STAFF REPORT SAN CLEMENTE PLANNING COMMISSION

SUBJECT: **Cultural Heritage Permit (CHP) 19-047, Gordnier Addition, 103 W. Paseo De Cristobal,** a request to construct a second-story addition and remodel a single-family residence that abuts a historic property across the street at 104 W. Paseo De Cristobal and is within the RL-CZ zone.

Table 2 – DRSC Recommendations

SITE PLAN	
6/17/19	
PROJECT: ADDITION-KITCHEN REMODEL 103 W. PASEO DE CRISTOBAL SAN CLEMENTE, CA. 92672 AARON AND OLIVIA GORDNIER 103 W. PASEO DE CRISTOBAL SAN CLEMENTE, CA. 92672 (949) 283-0354	
A1

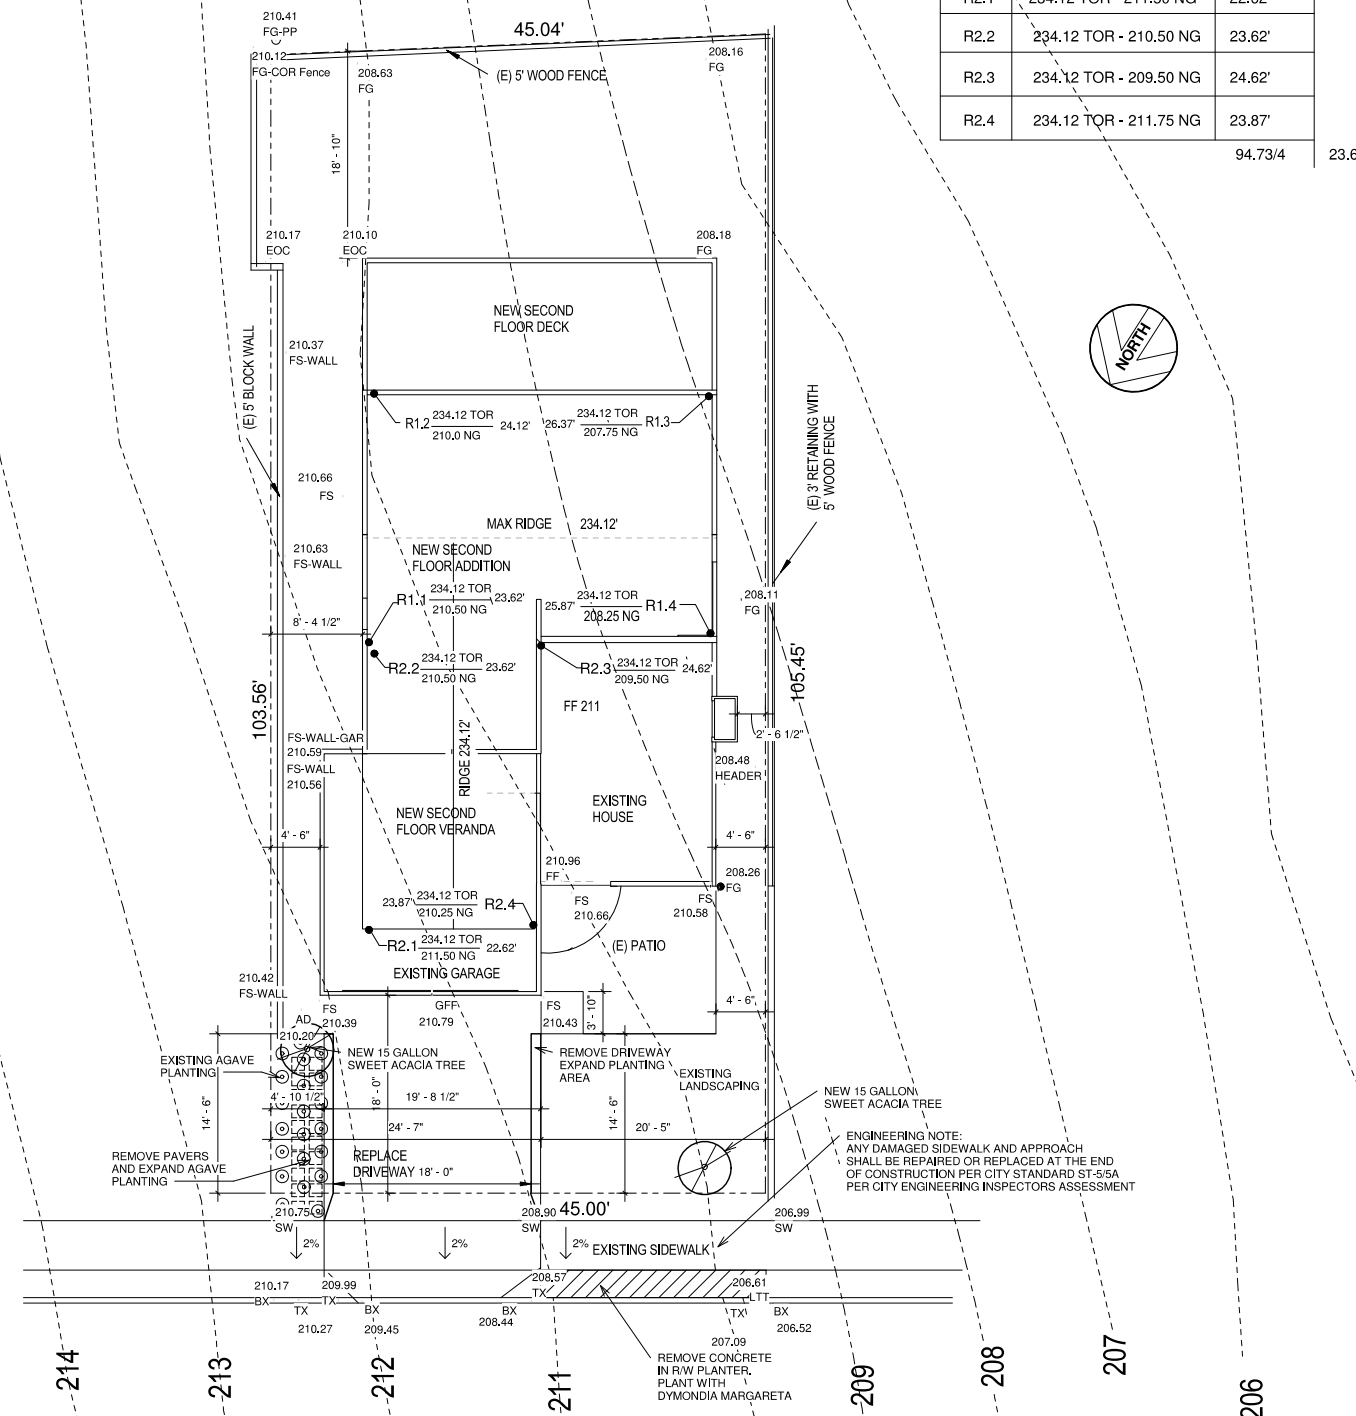
Comment/Recommendation:	Applicant Response:
3. Expressed a preference to bring the site into compliance with 50% front setback area landscape requirement and soften views from the historic home located across the street with additional landscaping in the parkway.	<i>Addressed.</i> The proposed plan adds additional landscaping along the edge of the existing driveway to expand the total landscape area to 50% and adds two sweet acacia trees. The City’s landscape consultant has recommended adding two queen palms into the parkway.

6. Discussed the concrete patch that does not match the historic sidewalk tile, and recommended converting the concrete parkway into landscaping.	<i>Addressed.</i> The applicant has indicated that the concrete would be replaced with tiles to match the historic tiles that characterize the sidewalk on Paseo de Cristobal.

④ FRONT
1/4" = 1'-0"

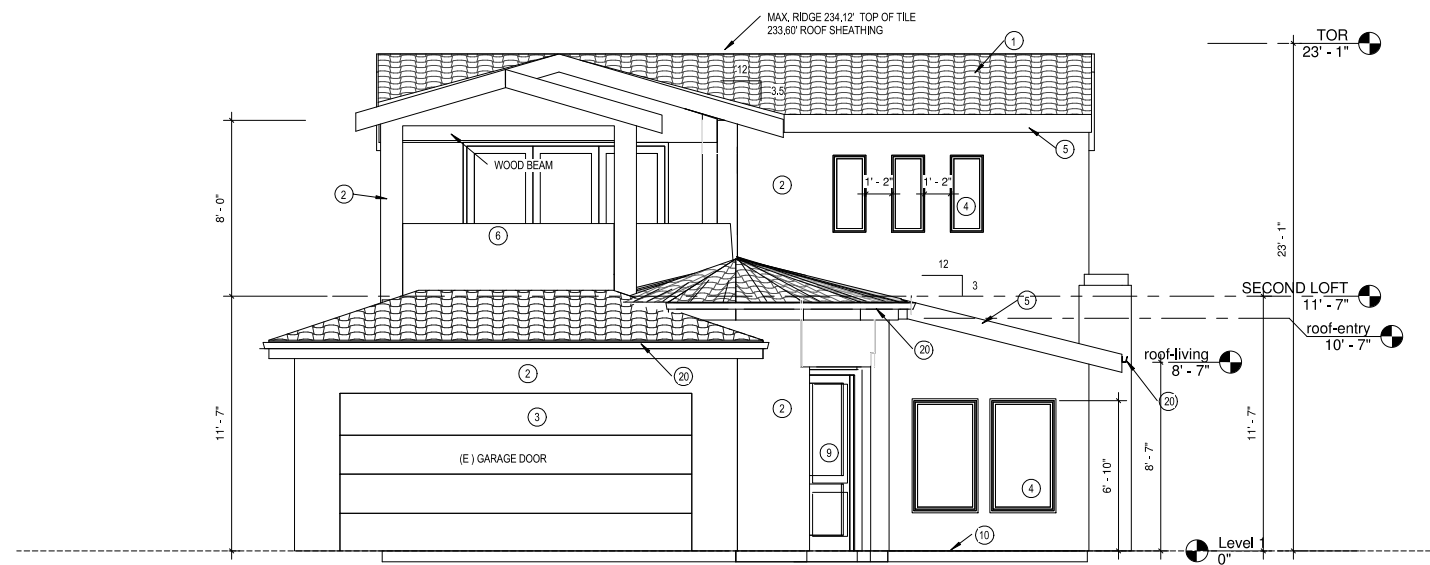
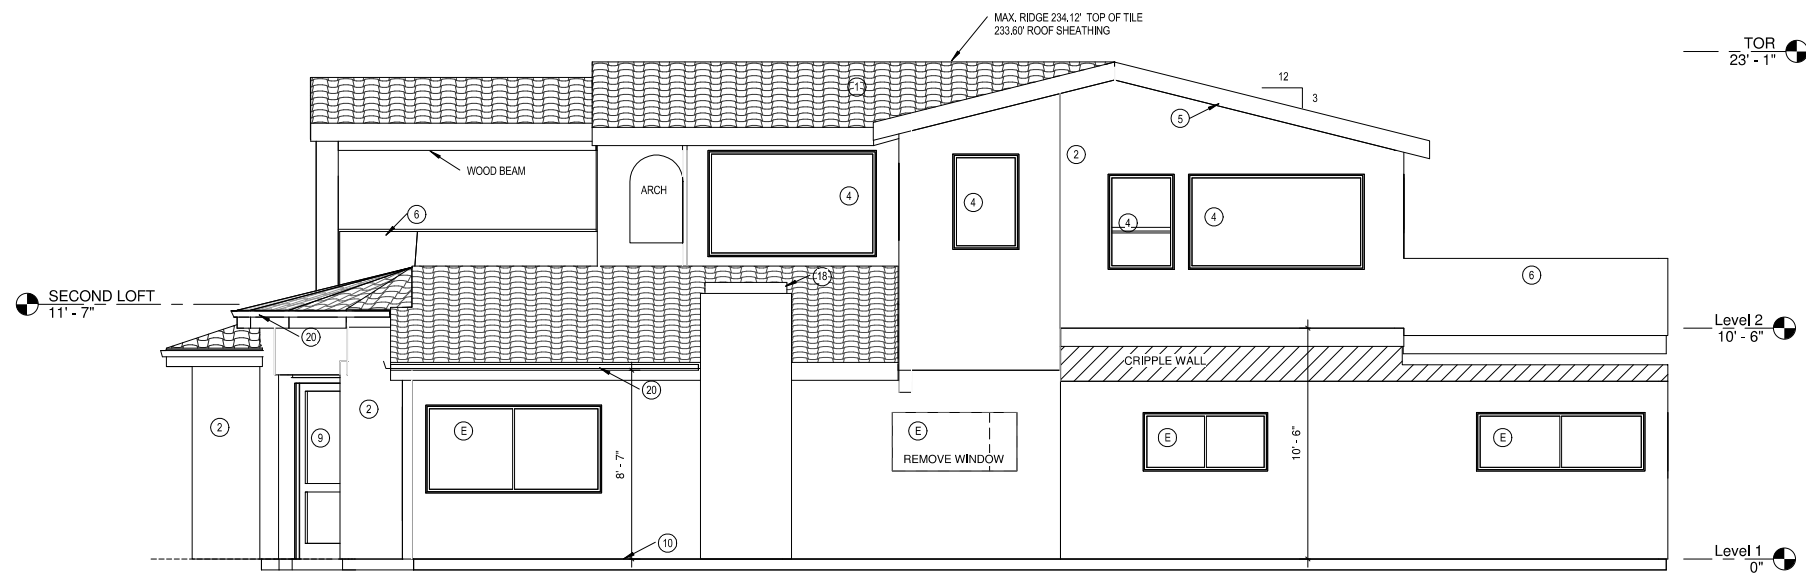
Comment/Recommendation:	Applicant Response:
<p>1. The front and side elevations of the veranda appear disjointed. Recommended removing the arched feature and replacing with a squared off or corbel feature. It was also suggested that the veranda roof could be pulled back to simplify the front elevation and provide more separation from the turret and other roofing elements of the front elevation.</p>	<p><i>Partially Addressed.</i> The arched opening was removed in favor of a squared off gable above the 2nd story veranda. The portion of the veranda above the turret was pulled back to accommodate comment #5 below.</p>
<p>2. Enlarge the chimney which appears short and out of place with the new 2nd story addition. Accentuate the chimney with a different color/shape/material. Provide a detail of the intended copper chimney cap.</p>	<p><i>Not Addressed.</i> Staff recommends a condition of approval to remove the chimney as it would no longer be needed to accommodate a direct vent gas fireplace.</p>

- Indicated the architecture appears cluttered, especially at the nexus of the varying roof types.
- The front and side elevations of the veranda appear disjointed. Recommended removing the arched feature and replacing with a squared off or corbel feature. It was also suggested that the veranda roof could be pulled back to simplify the front elevation and provide more separation from the turret and other roofing elements of the front elevation.

ROOF PLAN	
6/17/19	
PROJECT: ADDITION-KITCHEN REMODEL 103 W. PASEO DE CRISTOBAL SAN CLEMENTE, CA. 92672 AARON AND OLIVIA GORDNIER 103 W. PASEO DE CRISTOBAL SAN CLEMENTE, CA. 92672 (949) 283-0354	
5

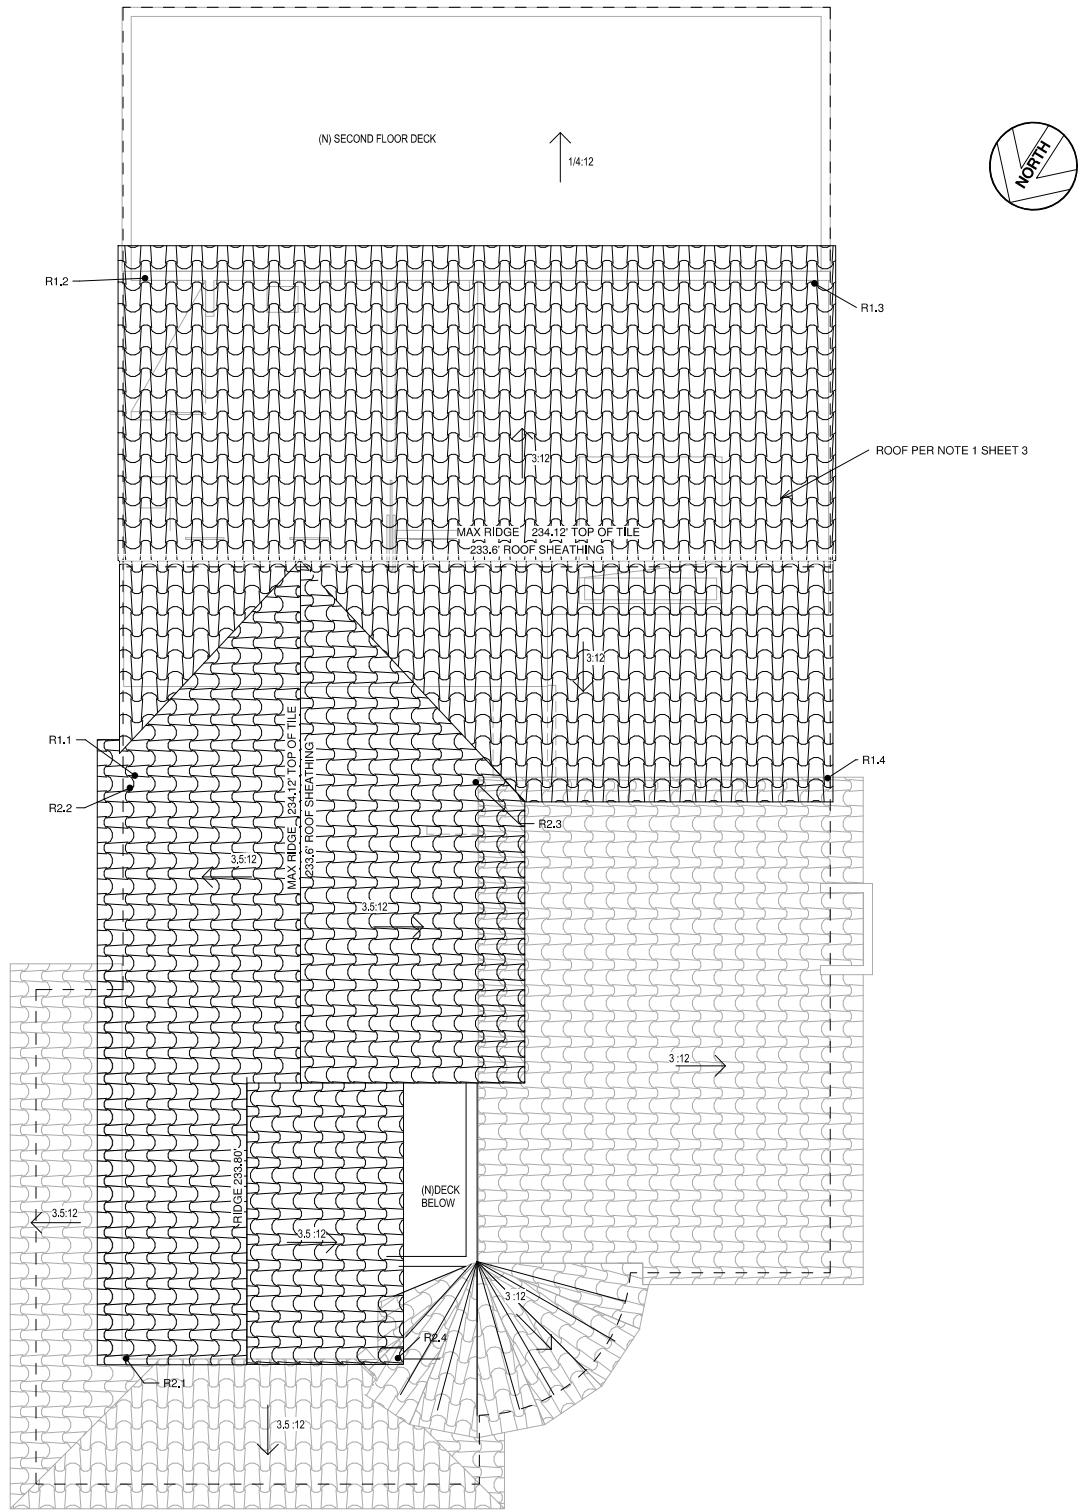
4. Indicated the architecture appears cluttered, especially at the nexus of the varying roof types. Recommended simplifying the overall building design to reduce the amount of articulation.	<i>Partially Addressed.</i> The removal of the arched opening and alteration of the turret connection to the existing roofing has helped to create a cleaner appearance.

5. Commented that the roof of the entry turret feature could be improved by originating from a right angle of the existing roofing instead of popping out from a 45-degree angle from the adjoining roofing.	<i>Addressed.</i> The turret feature now extends from a 90-degree break in the roof plane.
